Subdivision and Land Development Cover  
Page for SLD # 10-22

Project Name: Rebecca S. Padro &  
Karen P. Schrader

**RE: SLD#10-22, Montgomery Animal Hospital, 827 Bethlehem Pike  
Preliminary/Final Minor Land Development Plan  
Zoning Ordinance Compliance Review Letter**

Reference: Preliminary/Final Minor Land Development Plan Review  
827 Bethlehem Pike – Montgomery Animal Hospital  
Whitemarsh Township, Montgomery County, Pennsylvania  
SLD #10-22

OPERATIONS AND MAINTENANCE OF PERVIOUS PAVEMENT STORMWATER MANAGEMENT FACILITY.

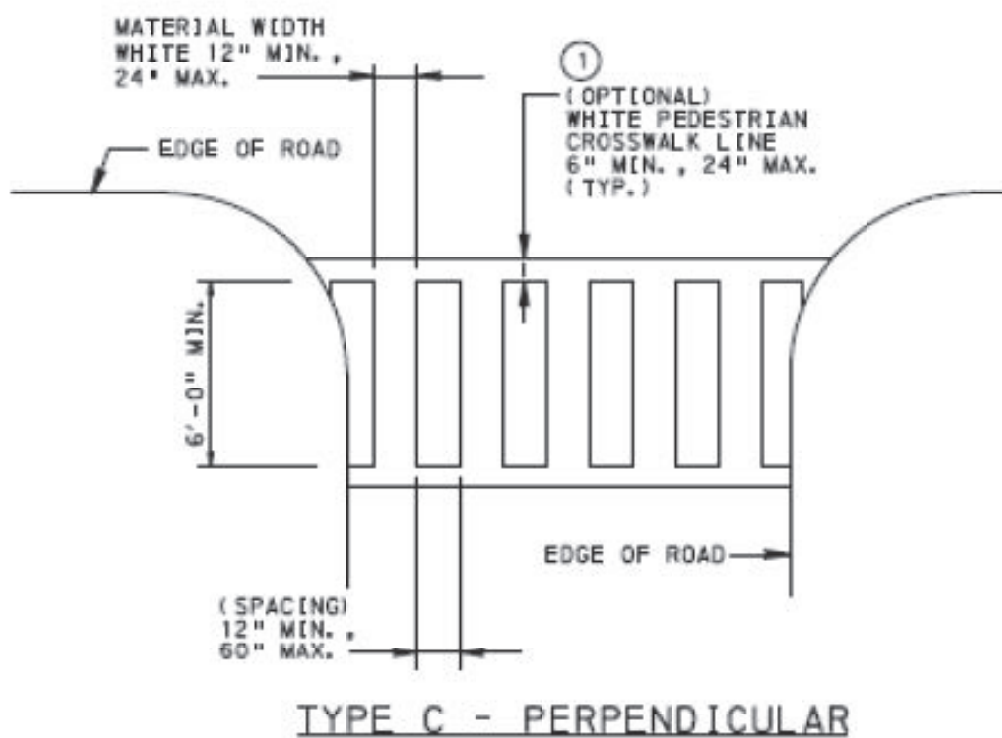
<u>Section</u>	<u>Description</u>
35. 58-4(B)(2)(o)	The pervious paving detail on Sheet 5 of 7 must be revised call for non-woven geotextile.
36. 58-4(B)(2)(q)	The plan must be revised to include an estimated development schedule and construction sequence for the site.
37. 58-11(H)(1)	The property owner shall sign an operations and maintenance agreement with the Township addressing stormwater BMPs that are to be privately owned.
